# ROADWAY AND STORM SEWER CONSTRUCTION PLANS FALCON MEADOWS AT BENT GRASS FILING NO. 4 FALCON, CO 80831 - EL PASO COUNTY CHALLENGER COMMUNITIES, LLC

PCD-ENGINEERING REVIEW COMMENTS IN BLUE BOXES WITH BLUE TEXT

> **Engineering Review** 08/19/2022 2:52:28 PM dsdrice JeffRice@elpasoco.com (719) 520-7877 **EPC Planning & Community Development Department**

# Construction Drawings (PlansProfiles)\_v1.pdf Markup Summary 8-29-2022

STORM DRAIN PLAN &

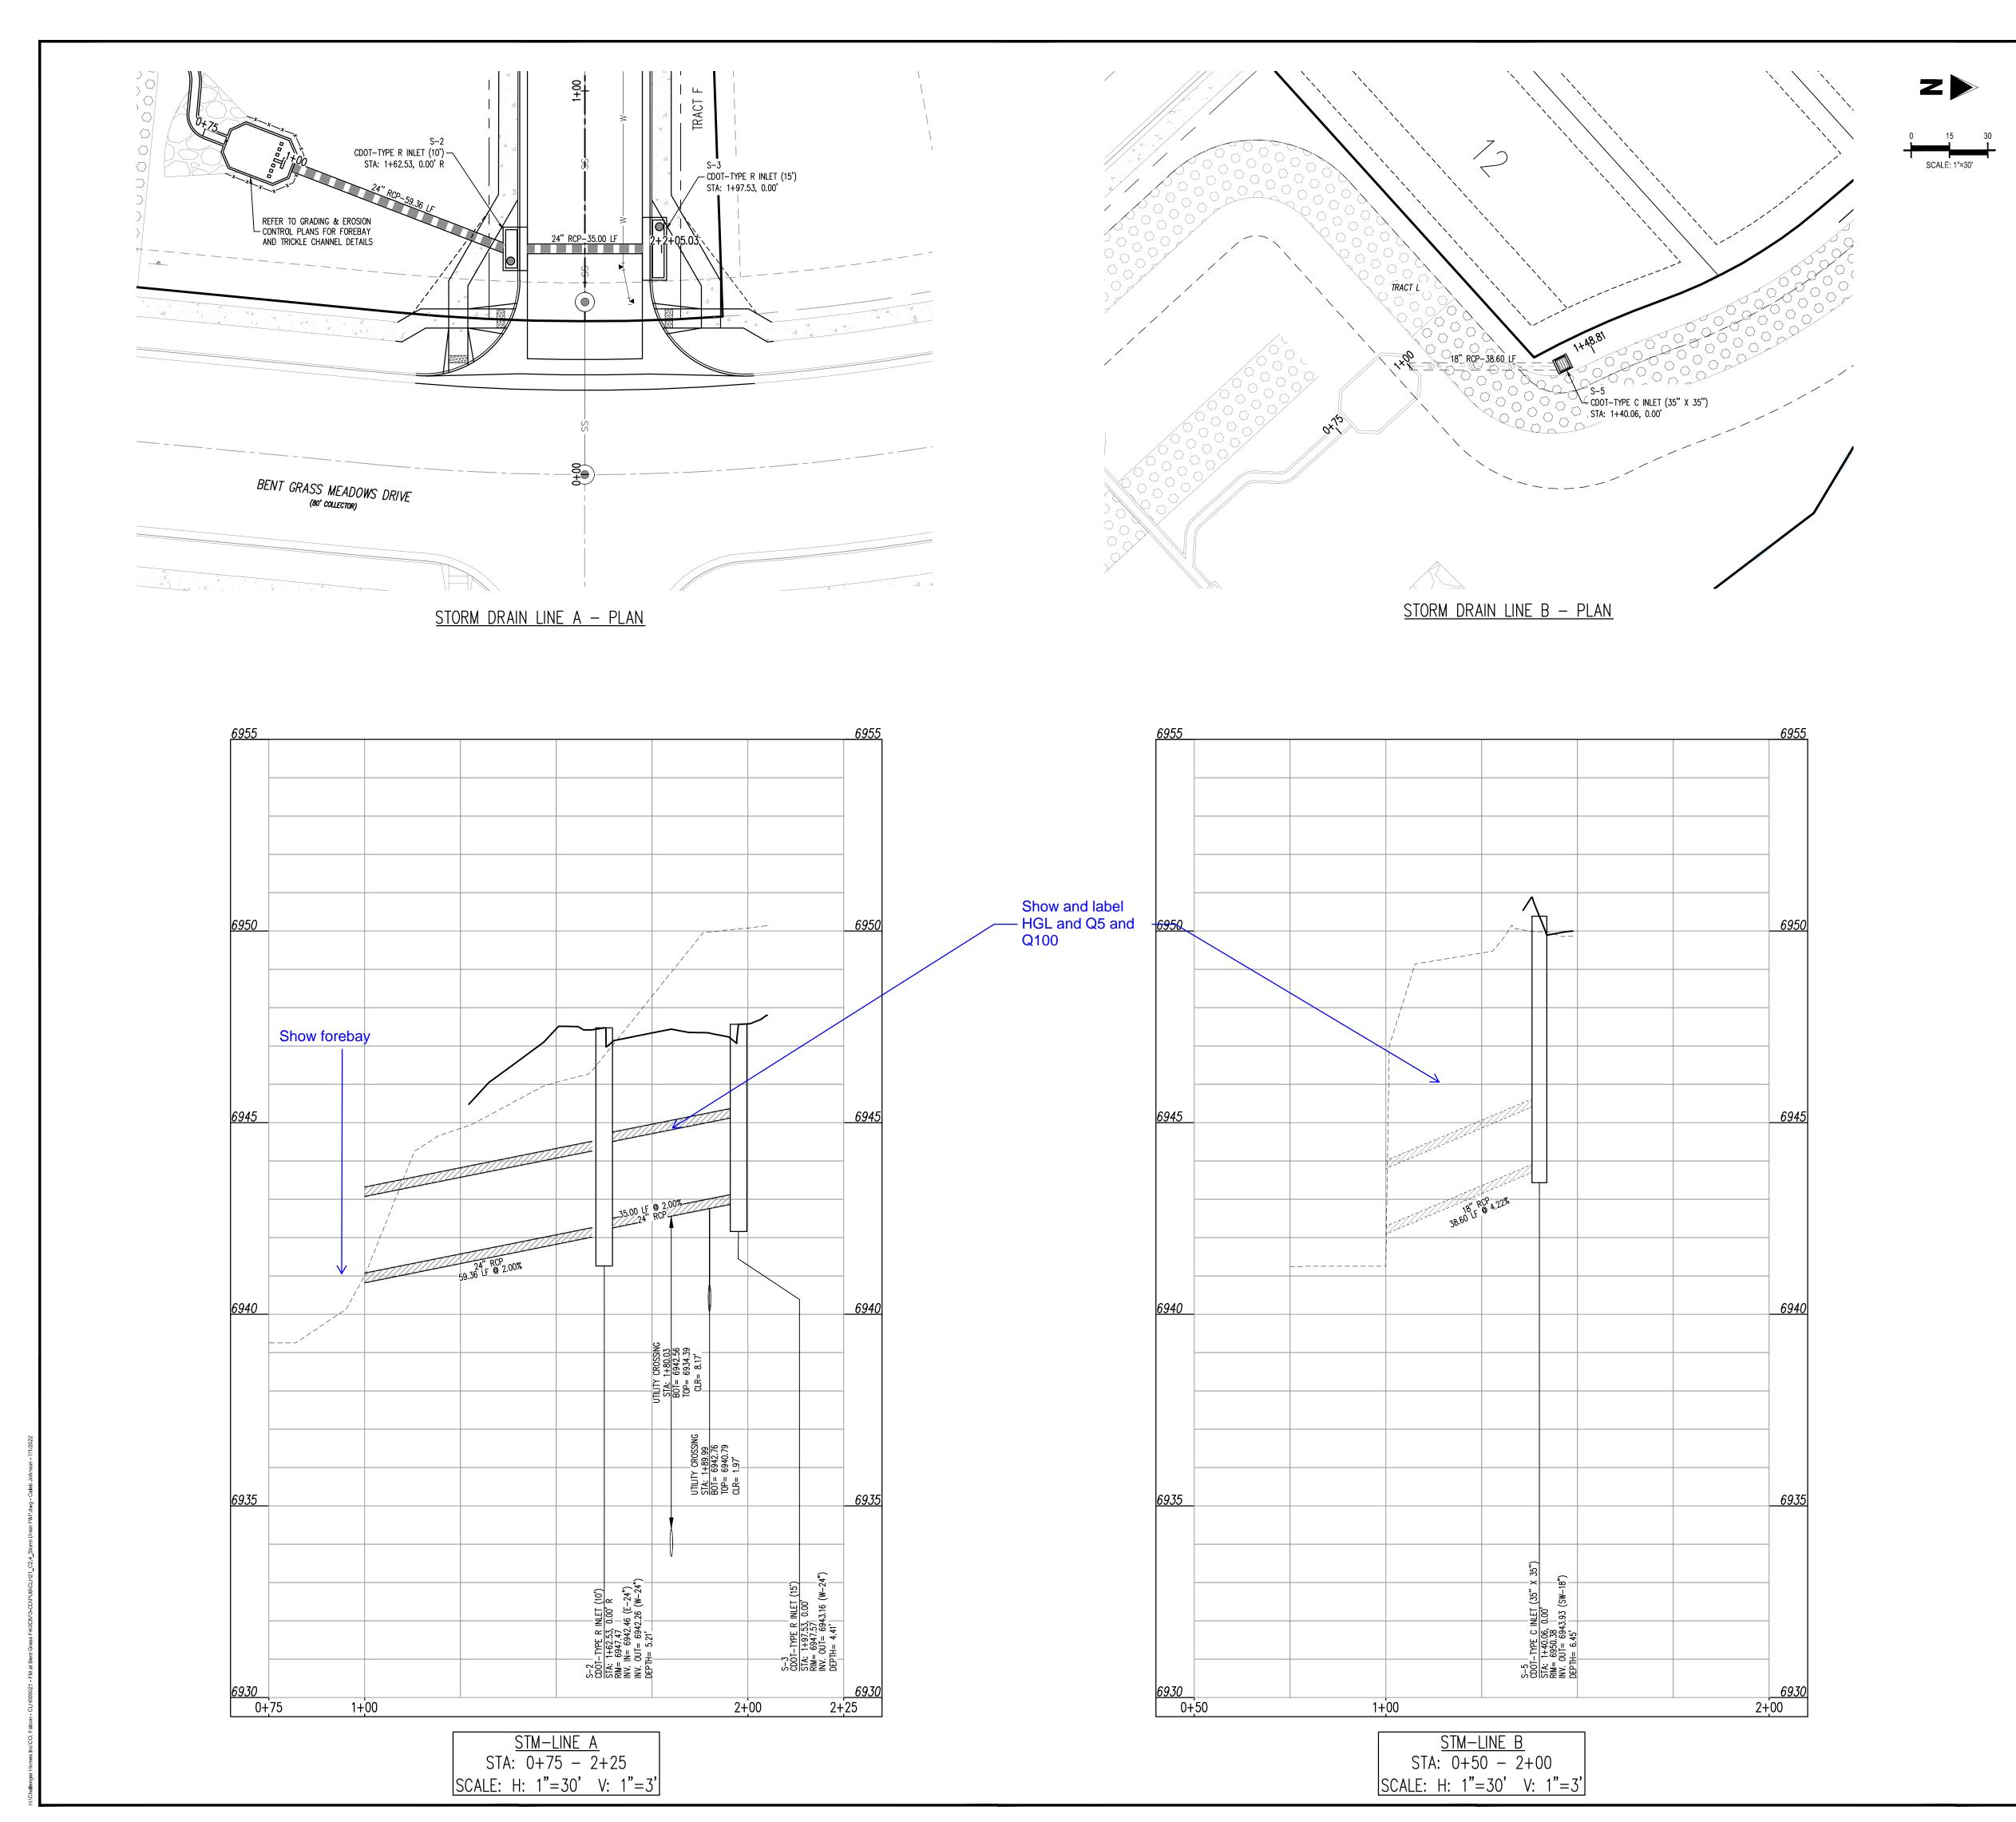
Show and label HGL and Q5 and Q100

Show forebay

INTERSECTION DETAIL

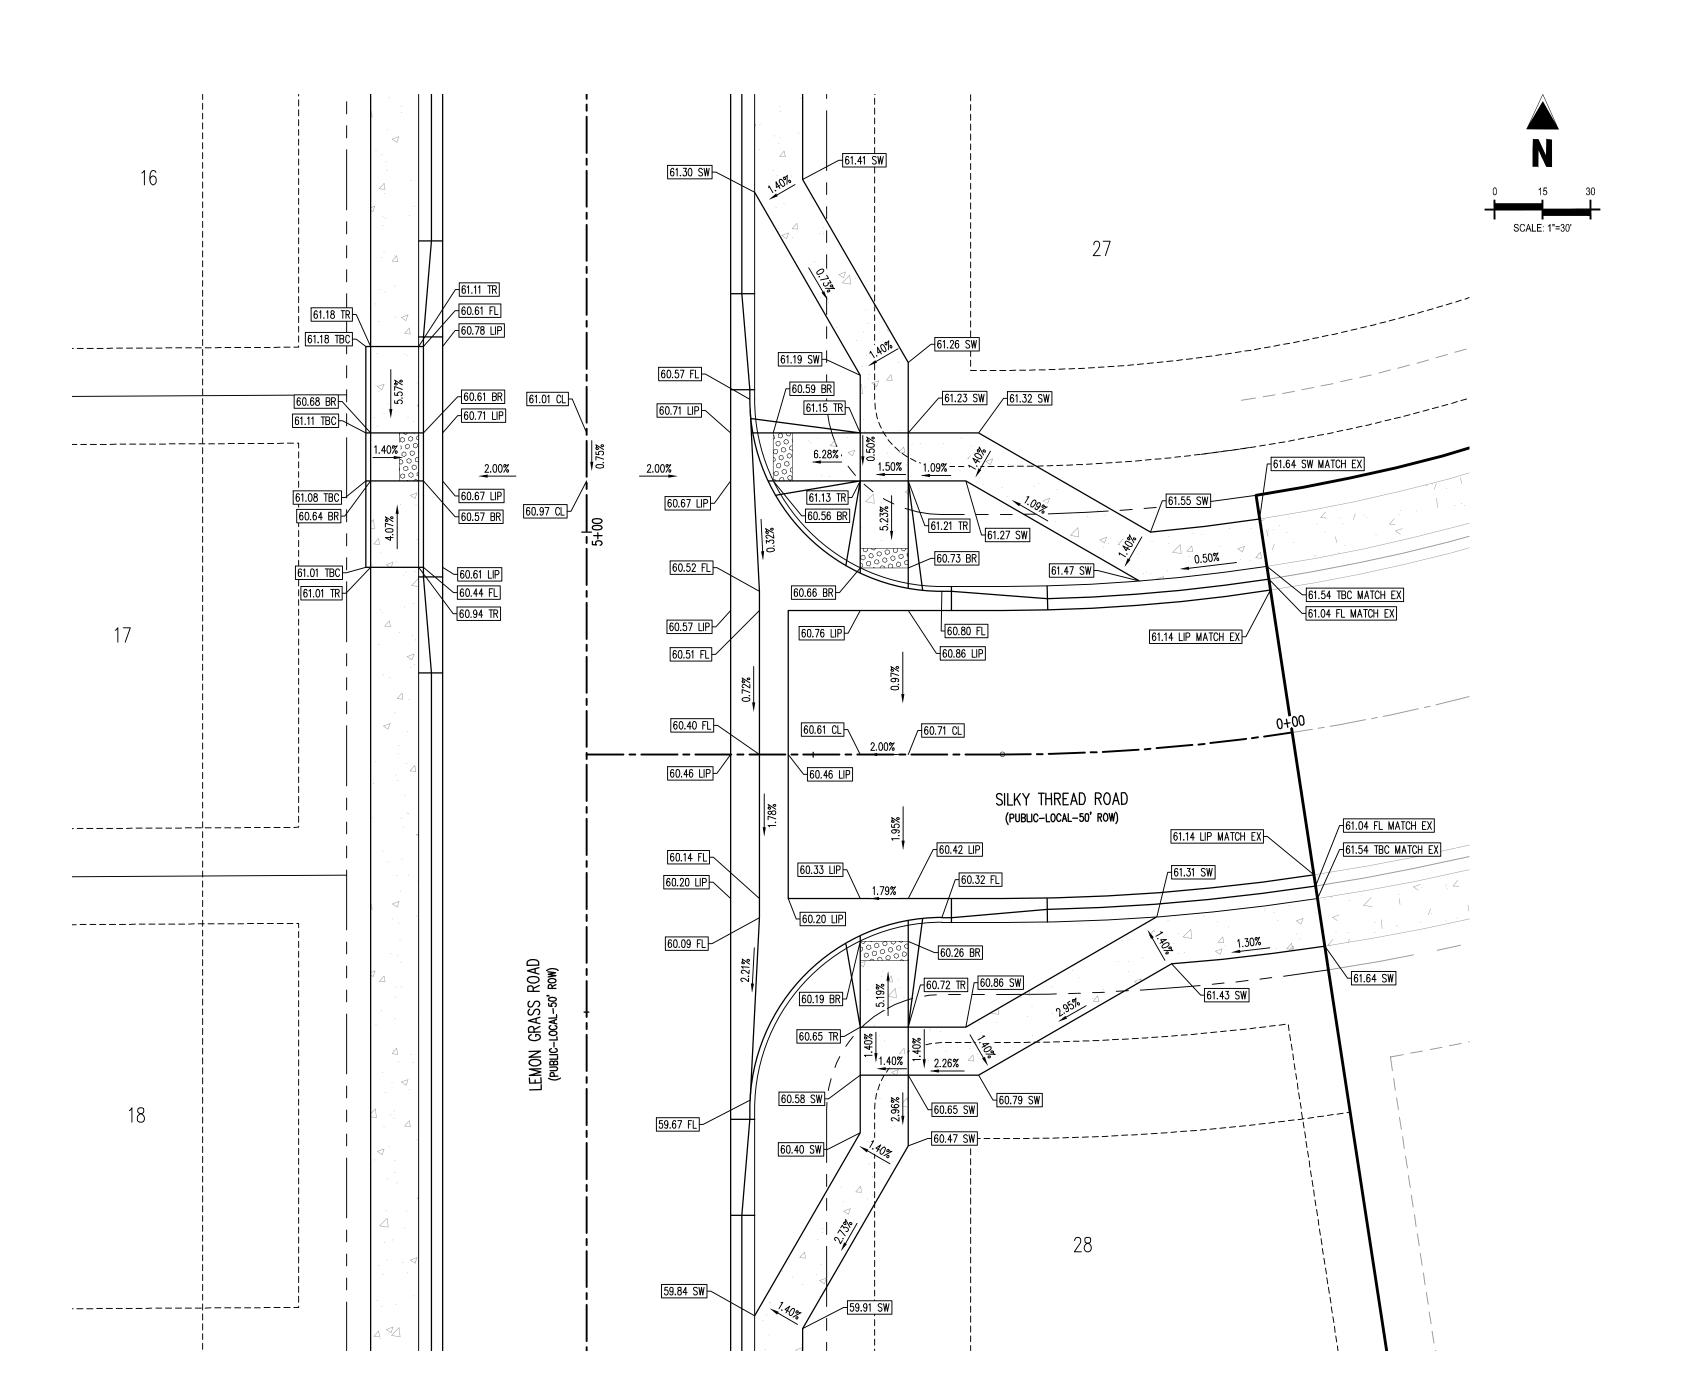
Show and label storm drain crossing
